# 1809 N TEJON RENOVATION – REPORT OF ACCEPTABILITY

Historic Preservation Board - September 9, 2024

Staff Report by City Planner: William Gray

File Number	Application Type	Decision Type
HIST-24-0012	Report of Acceptability	Quasi-Judicial

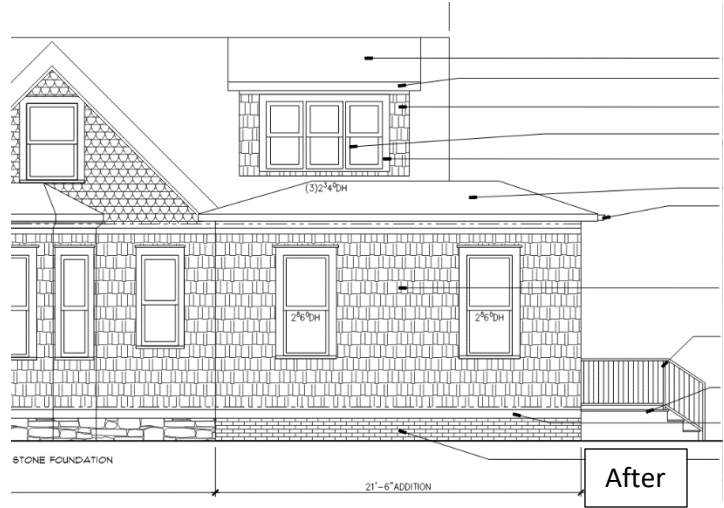
- 1) Removes the windows and accent dormer from the existing front porch. The new design for the front porch is more open and inviting (also invokes the civic character of a traditional front porch). The enclosure of front porches is not recommended by the Interpretive Guide for the North End Historic District because most front porches were designed to be open.

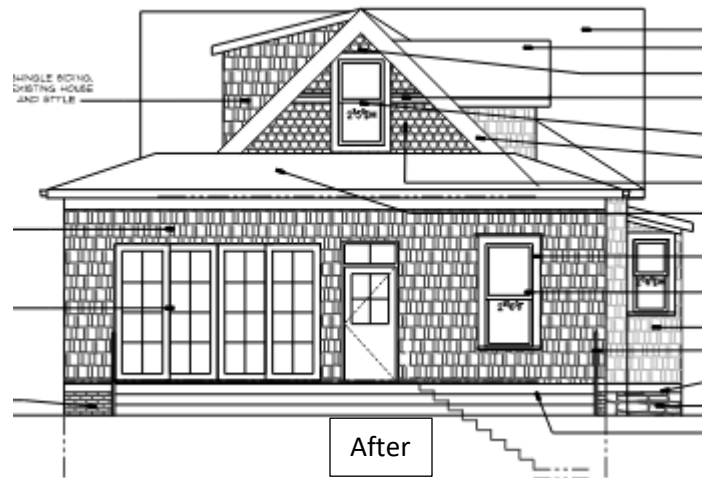
- 2) Remove the existing sleeping room, replacing it with an addition to the rear of home and a new dormer to the south (side elevation). This change improves the balance or symmetry of the home from front to back with the addition of the new dormer and the location and type of windows.

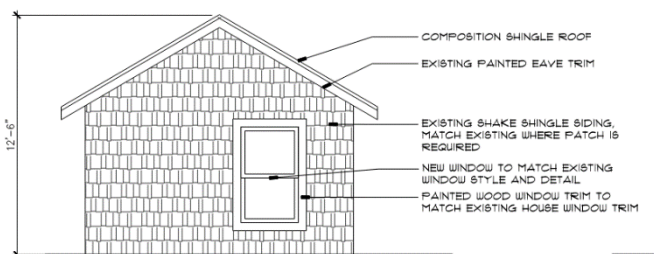
- 3) Removes the existing sleeping room, replacing it with a new addition and deck, and relocate the existing basement access to the interior of the home. A reason for removing the sleeping room is its poor construction and to reveal the prominent gable end of this historic home.
